# ADDENDUM

ADDENDUM NO.: 3  
PROJECT NAME: ORIOLE PARK ELEMENTARY SCHOOL ANNEX/RENOVATION  
PROJECT NO.: 05720  
CONTRACT NO.: C1559  
DATE OF ISSUE: May 30, 2014

## NOTICE OF CHANGES, MODIFICATIONS, OR CLARIFICATIONS TO CONTRACT DOCUMENTS

ASK-02  
05/30/2014

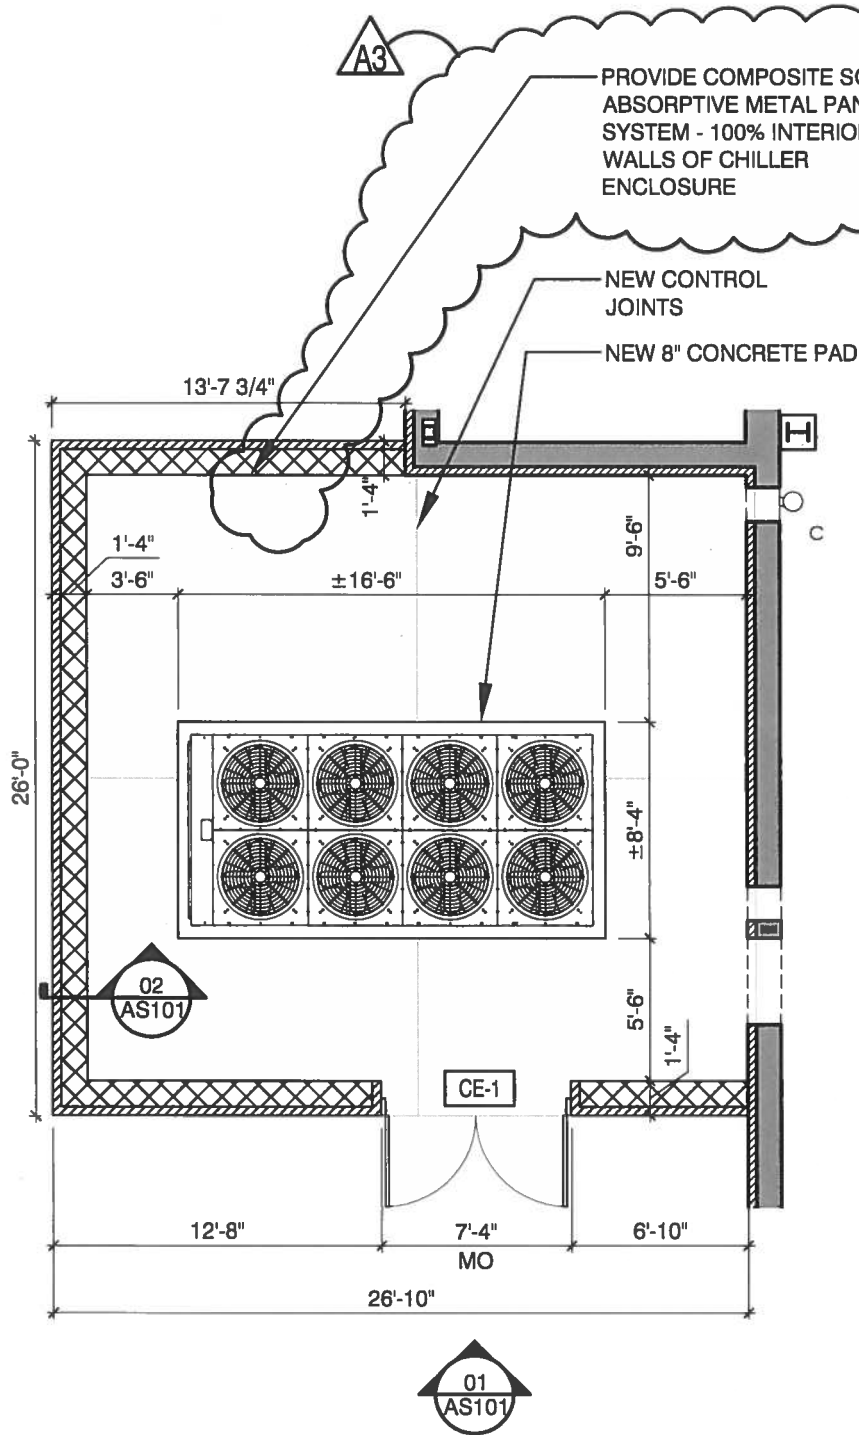
1. Sheet AS101 – **REVISE** Plan to identify the composite sound absorptive metal panel. Sound absorptive panels are to be provided and installed on the full interior wall of the chiller. See attached ASK-02 dated 05/30/2014.
2. Sheet A600/A601 – **REVISE** Equipment Legend **SCOPE NOTE** to read as follows “PROVIDE 1 PROJECTION SCREEN IN ALL CLASSROOMS INCLUDING KINDERGARTEN & PRE-K. SEE SHEET A411 FOR TYPICAL CLASSROOMS WITH PROJECTION SCREEN NOTE. IN ADDITION, PROVIDE 1 PROJECTION SCREEN IN LUNCH ROOM, LIBRARY, COMPUTER CLASSROOM, SCIENCE CLASSROOM, AND EXISTING BUILDING ROOM 102.”
